## **PLANNING BOARD AGENDA FOR JANUARY 13, 2026 - 7:00 PM**

1. **Salem NIM, LLC Site Plan** – Public Hearing for change of use for 19,960 sq. ft. restaurant and entertainment use with conditional use permit for reduced parking and additional signage at 11 Mall Road, Map 107, Lot 11154. Continued from 12/9/2025.

Below please find our responses comments discussed in our December 9 2025 meeting and at the PB meeting. Below please find each comment followed by our response in **bold**.

# LYONS GROUP RESTAURANT AT THE MALL AT ROCKINGHAM PARK PLANNING BOARD SUBMISSION

Drawing Title  
EXISTING CONDITIONS

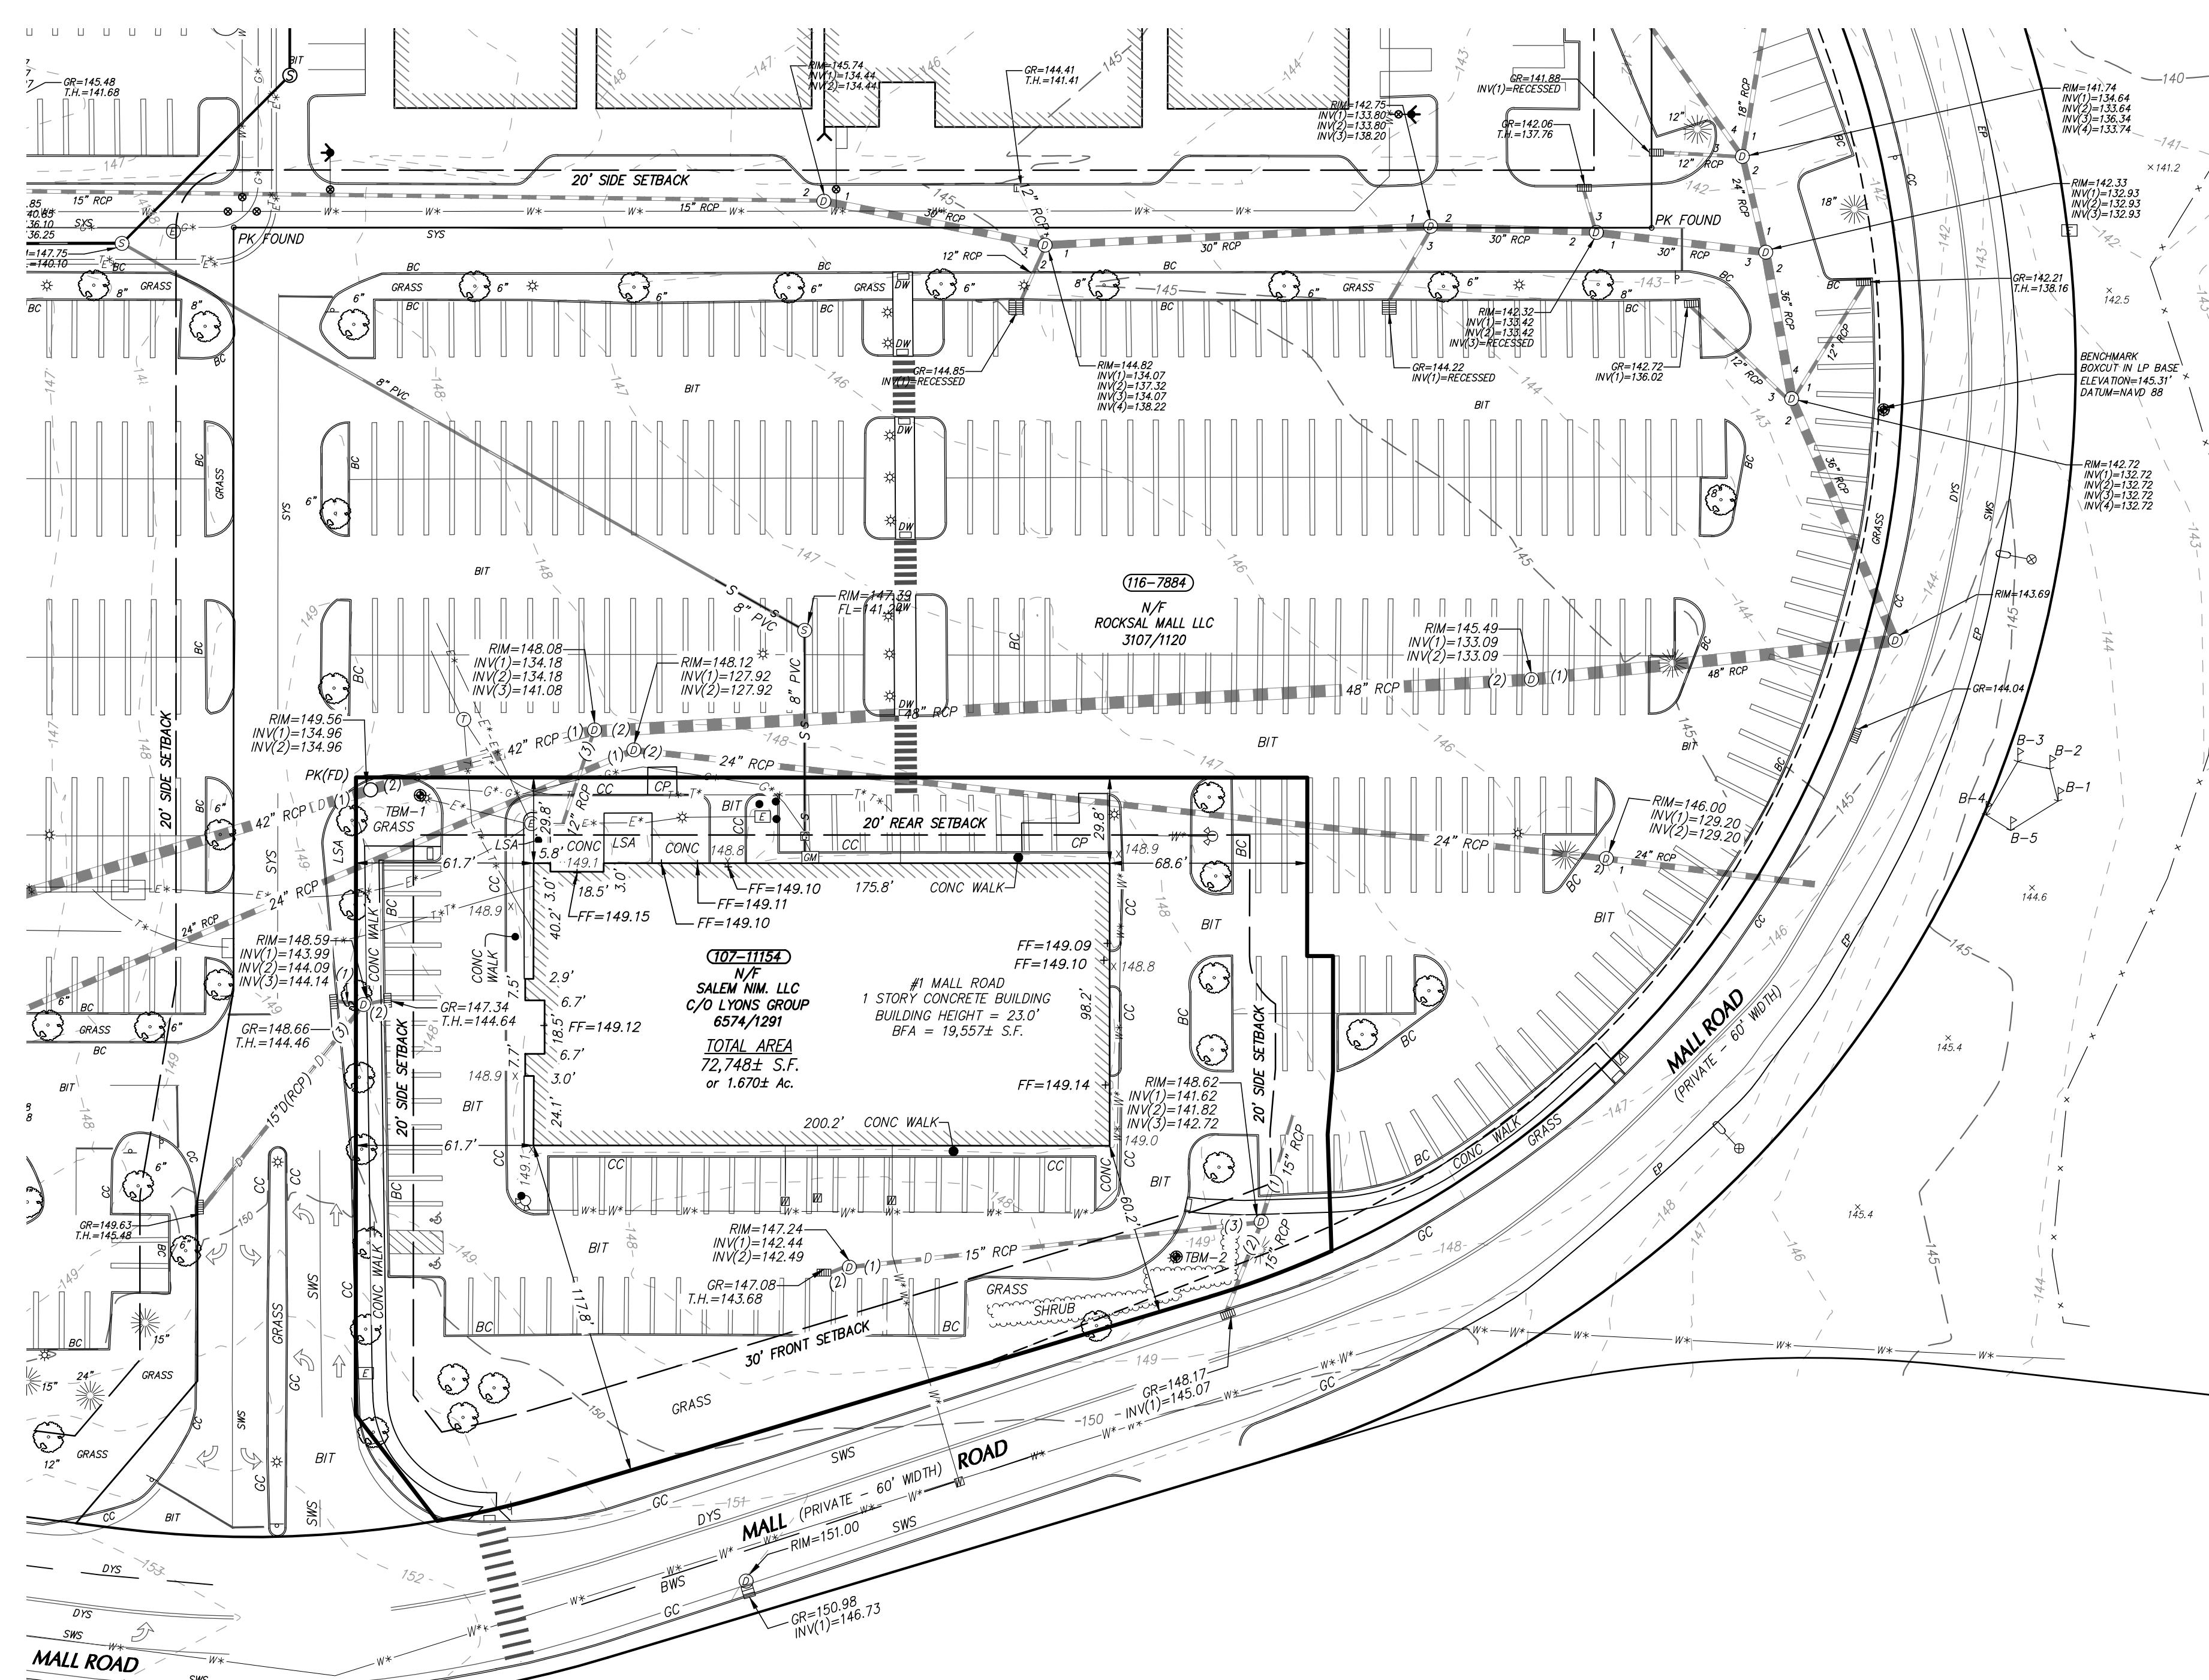
- Eliminate zoning table on Existing Conditions Plan

**COMMENT RESPONSE:** Zoning Table has been removed from VT901.

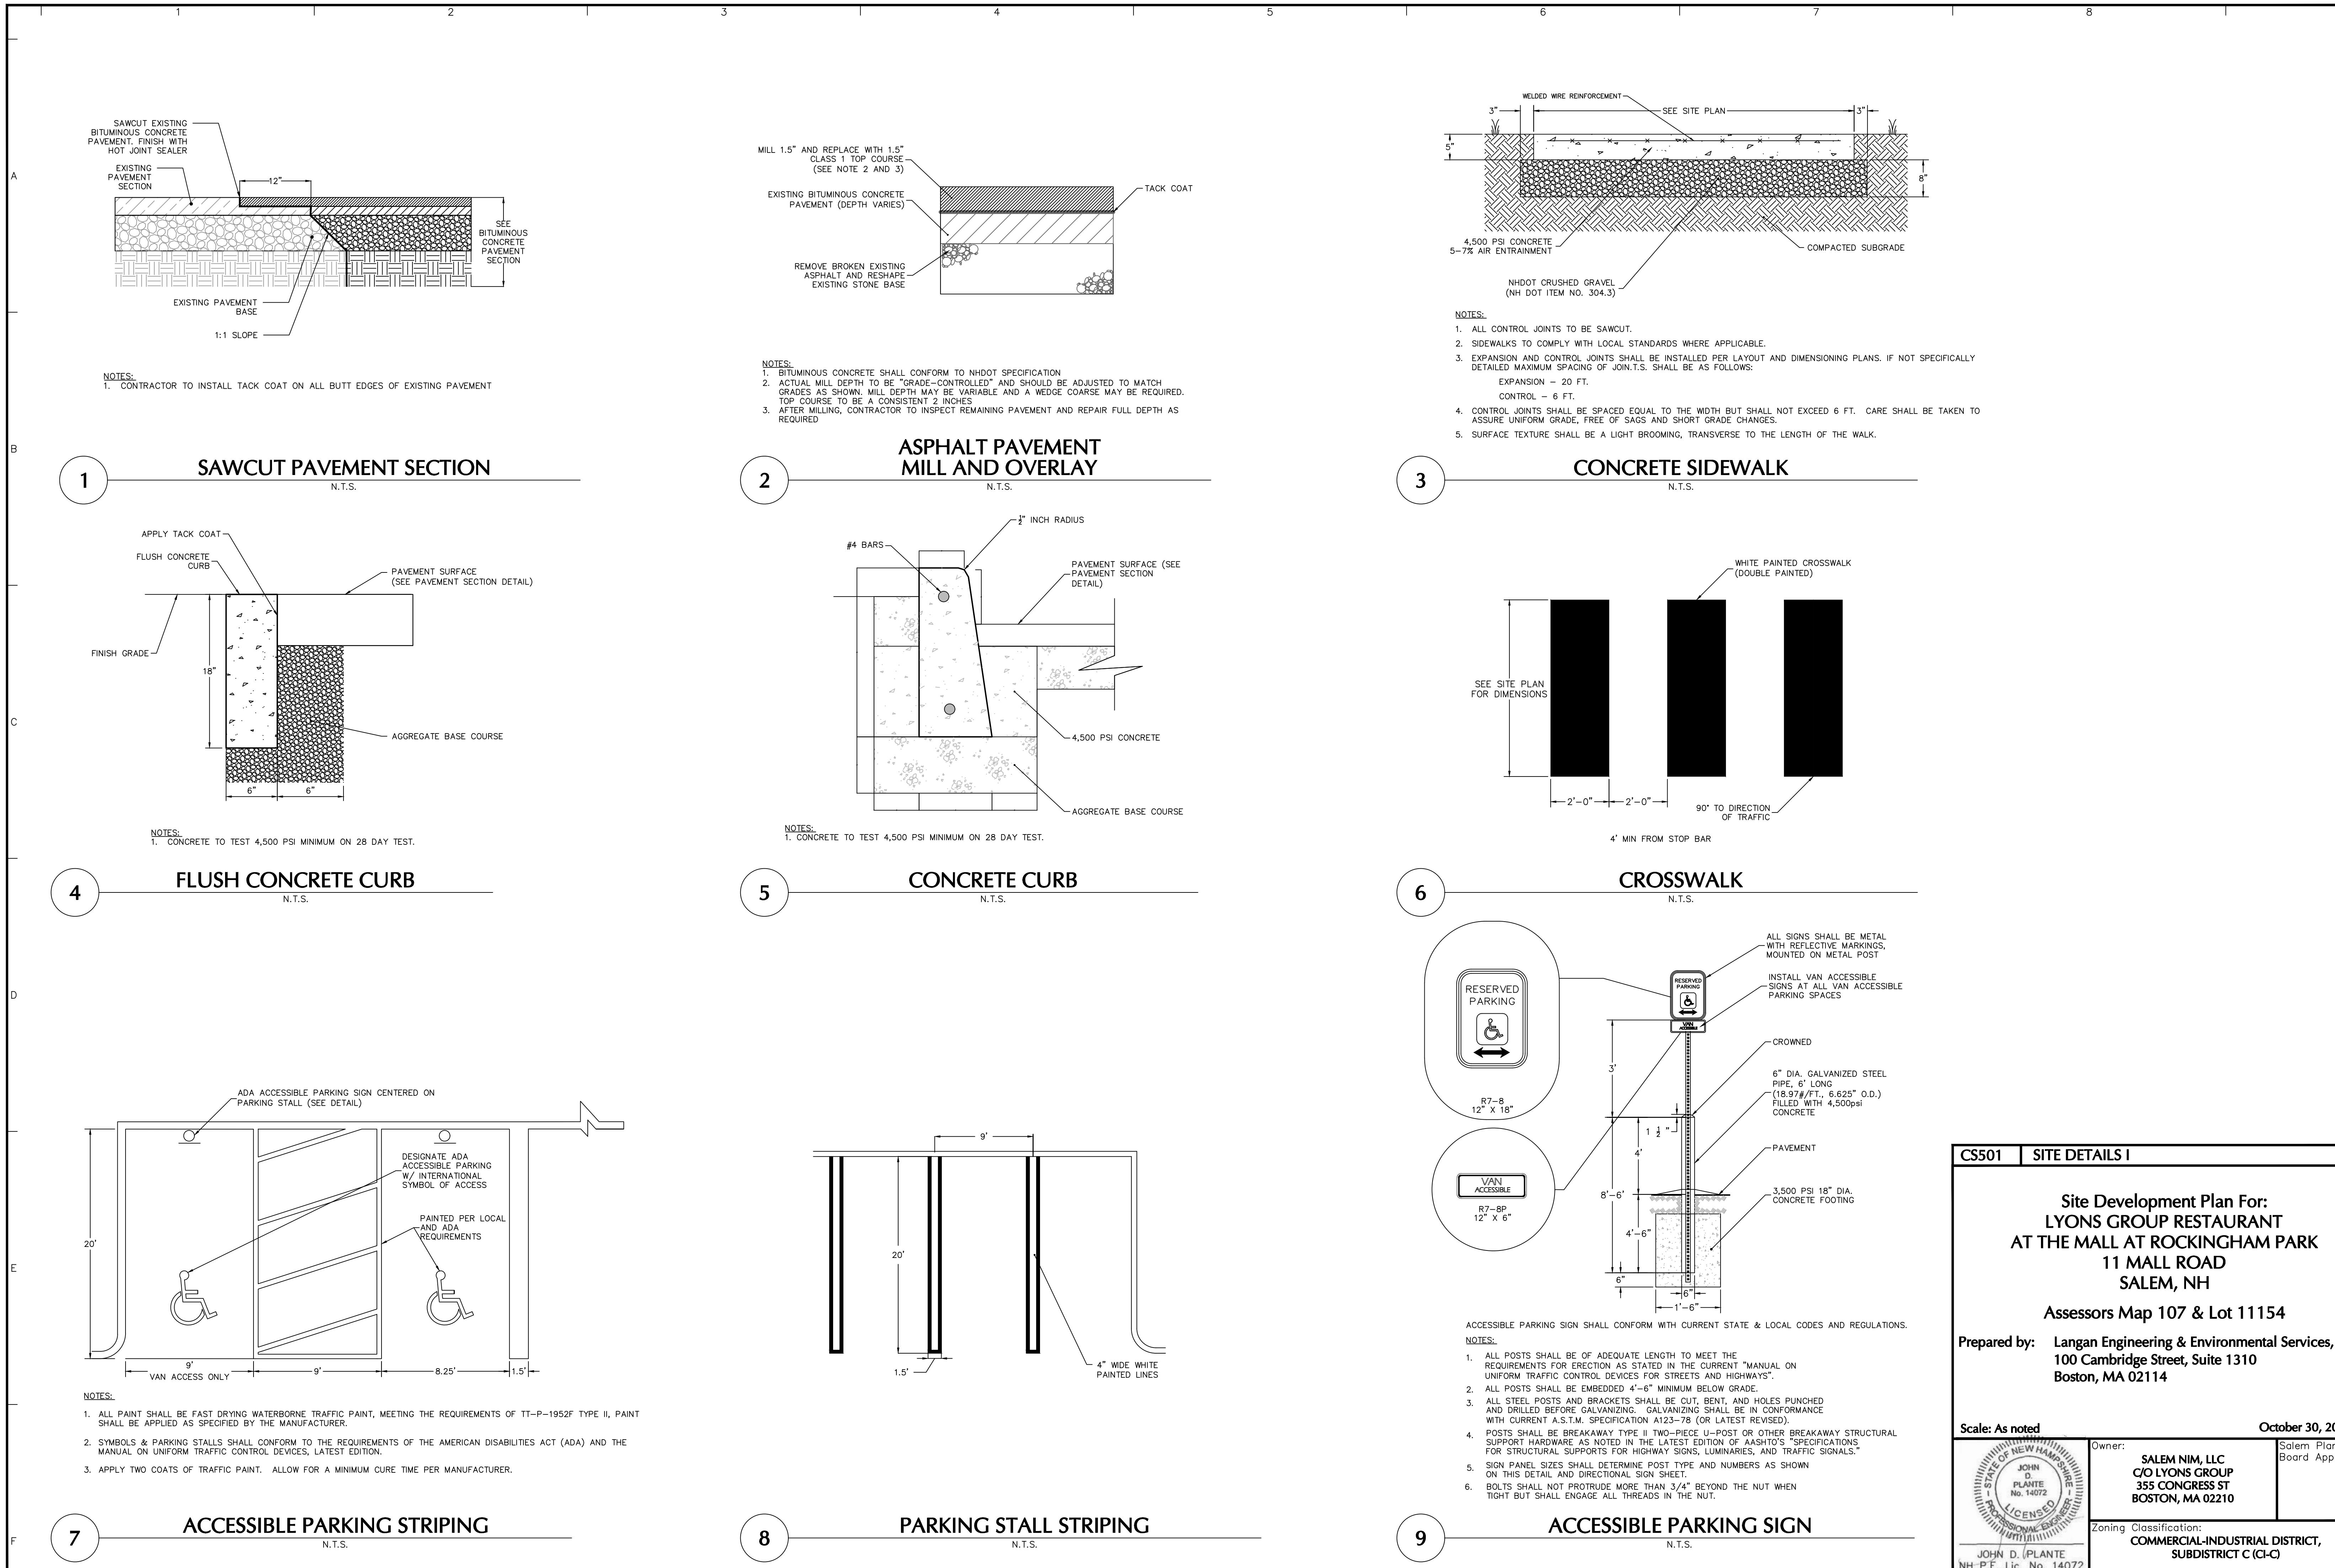
- Add pedestrian connection to north sidewalk

- Add tip down at ADA spaces to ped. connection to south

- Add dimension of striped space to south

**COMMENT RESPONSE:** Curb ramp with crosswalk has been added to the plans. Please see CS101.

**COMMENT RESPONSE:** Tip down to ADA spaces has been added to south sidewalk connection, as seen on CS101.

**COMMENT RESPONSE:** Dimensions have been added to restriped southern parking area, seen on CS101.
